Appl. No. 10/695,881
Amendment dated May 2, 2006
Reply to Office Action dated Feb. 2, 2006

REMARKS/ARGUMENTS

FIG. 4

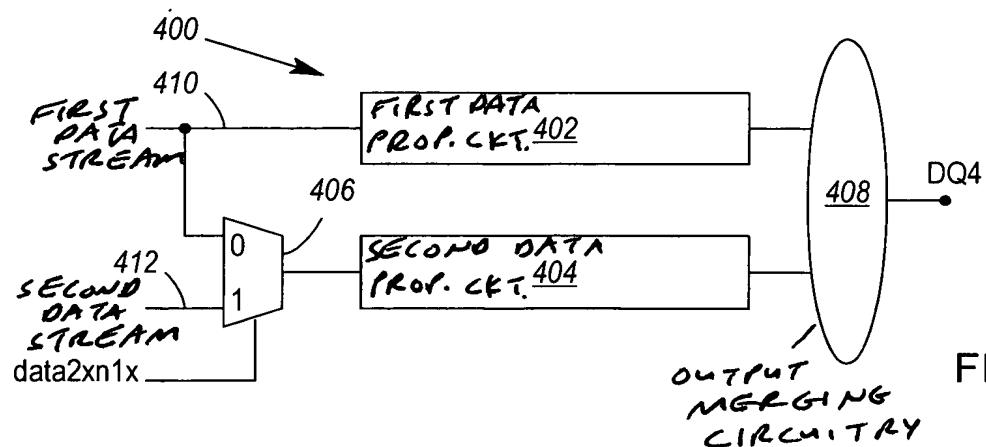
The drawings are objected to because in Fig 4, add label for Refs, 402, 404, 406, 408, 410, and 412 for --first propagation--, --second propagation--, --multiplexing stage--, --output merging--, --first data stream--, and --second data stream-- to facilitate the general understanding of the present invention for clarity.

The attached sheet of drawings includes changes to FIG. 4. This sheet, which includes FIGS. 4-6, replaces the original sheet including FIGS. 4-6. In FIG. 4, text labels have been added to the boxes illustrated therein.

Although applicants believe that figures are generally most appropriately labeled with reference numbers, and that FIG. 4 is so labeled, applicants have amended FIG. 4 to add all of the Examiner's labels, but for the label identifying a "multiplexing stage", which label is believed to be redundant given that the shape of object 406 clearly signifies a multiplexer. The amendments to FIG. 4 are not believed to add new matter.
